APPLICATION NO.	FILING DATE	FIRST NAMED INVENTOR	ATTORNEY DOCKET NO.	CONFIRMATION NO.
10/686,458	10/14/2003	Robert Bland	2003P14123US	7250
7590	12/06/2004		EXAMINER	
Siemens Corporation Intellectual Property Department 170 Wood Avenue South Iselin, NJ 08830			RODRIGUEZ, WILLIAM H	
			ART UNIT	PAPER NUMBER
			3746

Office Action Summary	Application No.	Applicant(s)
	10/686,458	BLAND ET AL.
	Examiner	Art Unit
	William H. Rodriguez	3746

DETAILED ACTION

FIG. 2

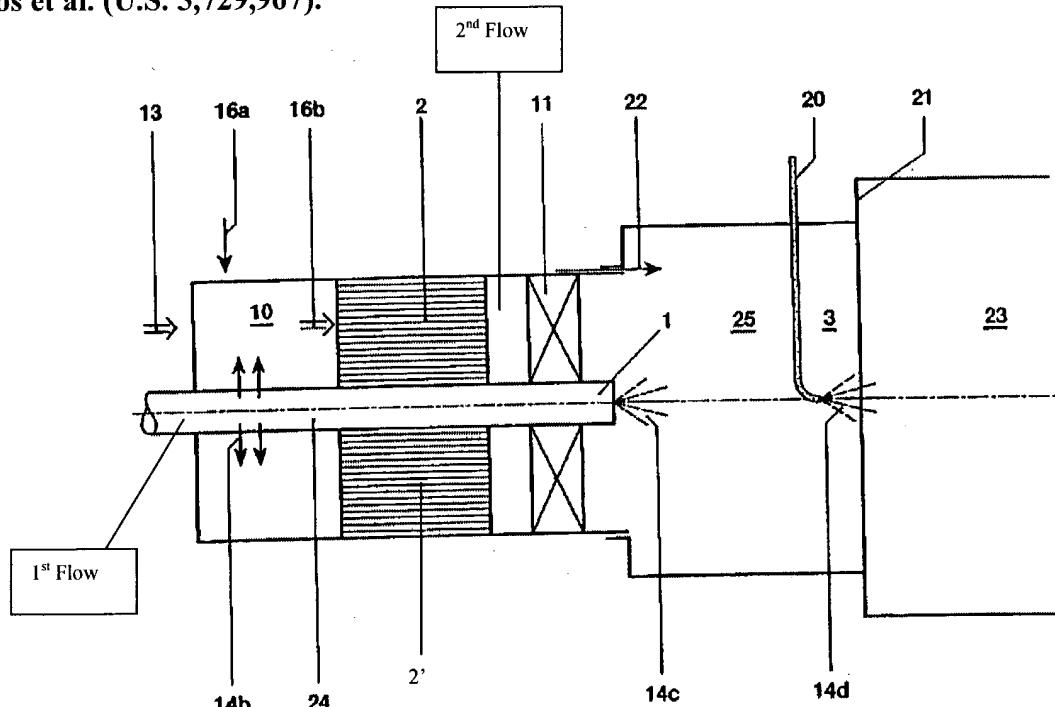
With respect to claim 1, **Joos** teaches a catalytic combustor system for a turbine engine comprising: at least one pilot nozzle 1 providing a first flow exiting the pilot nozzle, at least one catalytic module 2, 2' providing a second flow exiting the plurality of catalytic modules, wherein at least a portion of the second flow is substantially adjacent to at least a portion of the first flow; and at least one vortex forming device 11 positioned substantially within the path of the second flow, wherein at least one vortex is formed in at least a portion of the second flow, whereby at least a portion of the first flow mixes with at least a portion of the second flow. See particularly **Figure 2** of Joos.

With respect to claim 2, **Joos** teaches that the at least one catalytic module 2 substantially peripherally surrounds the pilot nozzle 1. See particularly **Figure 2** of Joos.

With respect to claim 3, **Joos** teaches that the at least one pilot nozzle 1 substantially peripherally surrounds the catalytic module 2'. See particularly **Figure 2** of Joos.

With respect to claim 4, **Joos** teaches that the at least one vortex forming device 11 is a swirler.

With respect to claim 5, **Joos** teaches that the at least one vortex forming device 11 is positioned substantially adjacent to the exit of the at least one catalytic module 2.

With respect to claim 6, **Joos** teaches that the at least one vortex forming device 11 is positioned downstream of the at least one catalytic module 2.

With respect to claim 7, **Joos** teaches that the vortex forming device includes a plurality of surfaces, wherein each of the surfaces is substantially oblique to the path of the second flow (inherent that a typical swirler has surfaces that are oblique to the flow path in order to create the vortex).

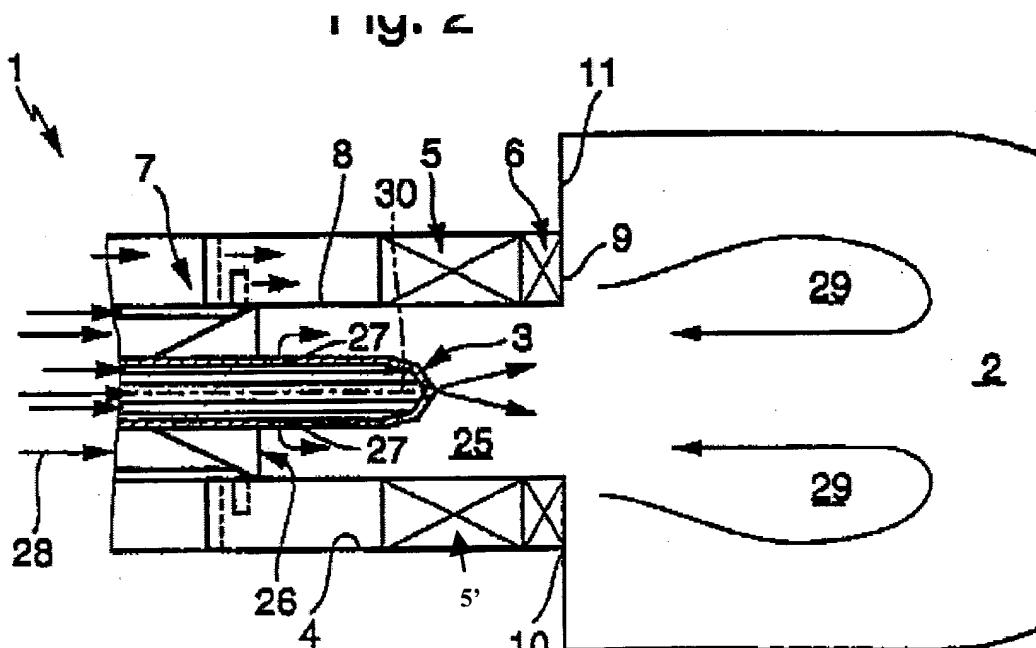
With respect to claim 1, **Eroglu** teaches a catalytic combustor system for a turbine engine comprising: at least one pilot nozzle 3 providing a first flow exiting the pilot nozzle, at least one catalytic module 5, 5' providing a second flow exiting the plurality of catalytic modules, wherein at least a portion of the second flow is substantially adjacent to at least a portion of the first flow; and at least one vortex forming device 6 positioned substantially within the path of the second flow, wherein at least one vortex is formed in at least a portion of the second flow, whereby at least a portion of the first flow mixes with at least a portion of the second flow. See particularly **Figure 3** of Eroglu.

With respect to claim 2, **Eroglu** teaches that the at least one catalytic module 5 substantially peripherally surrounds the pilot nozzle 3. See particularly **Figure 3** of Eroglu.

With respect to claim 3, **Eroglu** teaches that the at least one pilot nozzle 3 substantially peripherally surrounds the catalytic module 5'. See particularly **Figure 3** of Eroglu.

With respect to claim 4, **Eroglu** teaches that the at least one vortex forming device 6 is a swirler.

With respect to claim 5, **Eroglu** teaches that the at least one vortex forming device 6 is positioned substantially adjacent to the exit of the at least one catalytic module 5.

With respect to claim 6, **Eroglu** teaches that the at least one vortex forming device 6 is positioned downstream of the at least one catalytic module 5.

With respect to claim 7, **Eroglu** teaches that the vortex forming device 6 includes a plurality of surfaces, wherein each of the surfaces is substantially oblique to the path of the second flow (inherent that a typical swirler has surfaces that are oblique to the flow path in order to create the vortex).

With respect to claim 8, **Eroglu** teaches that the second flow is substantially laminar prior to encountering the vortex forming device 6 (inherent since the purpose of the swirler 6 is to create a turbulence/vortex to enhance mixing).

FIG. 3

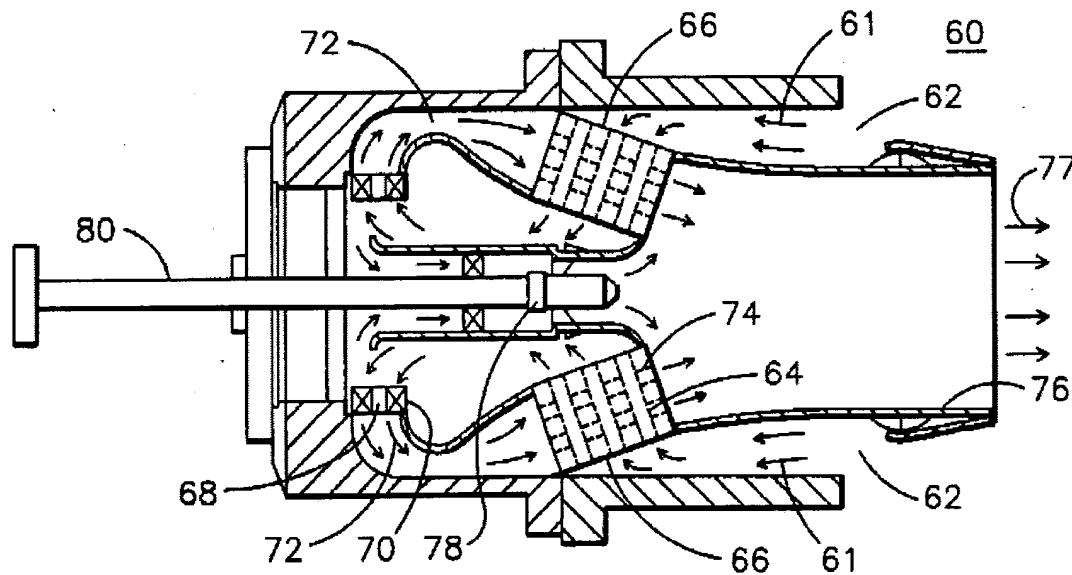
With respect to claim 1, **Newburry** teaches a catalytic combustor system for a turbine engine comprising: at least one pilot nozzle 78 providing a first flow exiting the pilot nozzle, at least one catalytic module 66 providing a second flow exiting the plurality of catalytic modules, wherein at least a portion of the second flow is substantially adjacent to at least a portion of the first flow; and at least one vortex forming device 70 positioned substantially within the path of the second flow, wherein at least one vortex is formed in at least a portion of the second flow, whereby at least a portion of the first flow mixes with at least a portion of the second flow. See particularly **Figure 3** of Newburry.

With respect to claim 2, **Newburry** teaches that the at least one catalytic module 66 substantially peripherally surrounds the pilot nozzle 78. See particularly **Figure 3** of Newburry.

With respect to claim 3, **Newburry** teaches that the at least one pilot nozzle 78 substantially peripherally surrounds the catalytic module 66. See particularly **Figure 3** of Newburry.

With respect to claim 4, **Newburry** teaches that the at least one vortex forming device 70 is a swirler.

With respect to claim 6, **Newburry** teaches that the at least one vortex forming device 70 is positioned downstream of the at least one catalytic module 66.

With respect to claim 7, **Newburry** teaches that the vortex forming device 70 includes a plurality of surfaces, wherein each of the surfaces is substantially oblique to the path of the second flow (inherent that a typical swirler has surfaces that are oblique to the flow path in order to create the vortex).

With respect to claim 8, **Newburry** teaches that the second flow is substantially laminar prior to encountering the vortex forming device 6 (inherent since the purpose of the swirler 70 is to create a turbulence/vortex to enhance mixing).
